NUMBER
DEP16067

**Addendum Number:** 01

**Addendum #1 – Questions During Pre-Bid Meeting  
Tub Run Highwall & Refuse – Phase II  
For DEP16067**

**TUB RUN HIGHWALL AND REFUSE, PHASE II  
ADDENDUM**

**DETAIL 34  
CONSTRUCTED ACCESS ROAD, TYP.**

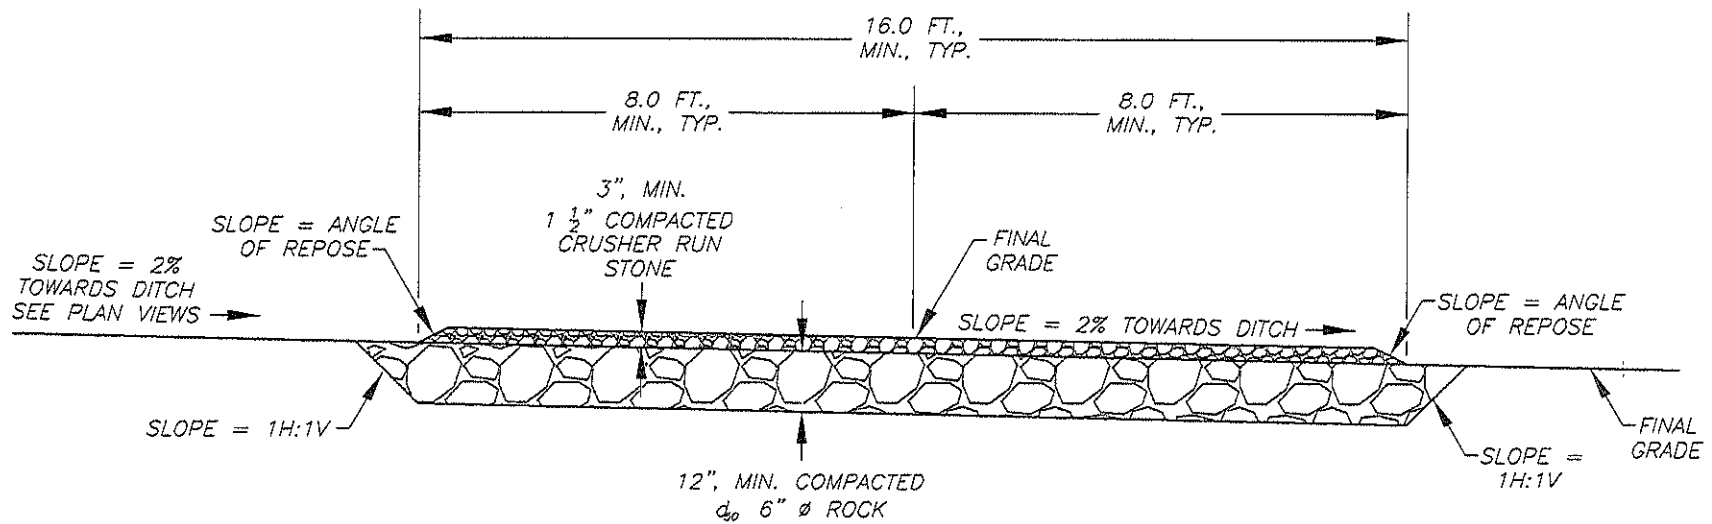
8. On Plan Sheet 88, the Constructed Access Road Detail, Detail 34, shall be modified as follows: The final grade in the location of the access road construction shall be undercut 1.0’ to accommodate placement of a rock base layer. The Constructed Access Road Detail shall be modified such that a 1.0’ (after compaction) minimum thick rock base is provided beneath the 3” (after compaction) layer of Crusher Run Stone and the separation fabric shall be deleted. The rock base shall meet the requirements for  $D_{50} = 6$ ” riprap as follows and the requirements for hardness as specified in 7.2.2.1 of the

Technical Specifications except that the rock shall not necessarily be required to consist of limestone. The riprap shall consist of rock such that 50% ranges from 6" to 9" in diameter, 35% ranges from 3" to 6" in diameter, and no more than 15% by weight is less than or equal to 3" in diameter. The rock base shall be roller compacted prior to placement of the Crusher Run Stone and the Crusher Run Stone layer shall be roller compacted as well. (See attached revised Typical Detail)

1. CRUSHER RUN STONE SHALL BE ROLLER COMPACTED.
2. 1 1/2" CRUSHER RUN STONE SHALL MEET THE GRADATION REQUIREMENTS FOR CLASS 1 AGGREGATE IN TABLE 704.6.2A OF THE WVDOH STANDARD SPECIFICATIONS FOR ROADS AND BRIDGES.
3. d<sub>50</sub> 6" ROCK SHALL COMPLY WITH THE ADDENDUM SPECIFICATIONS.
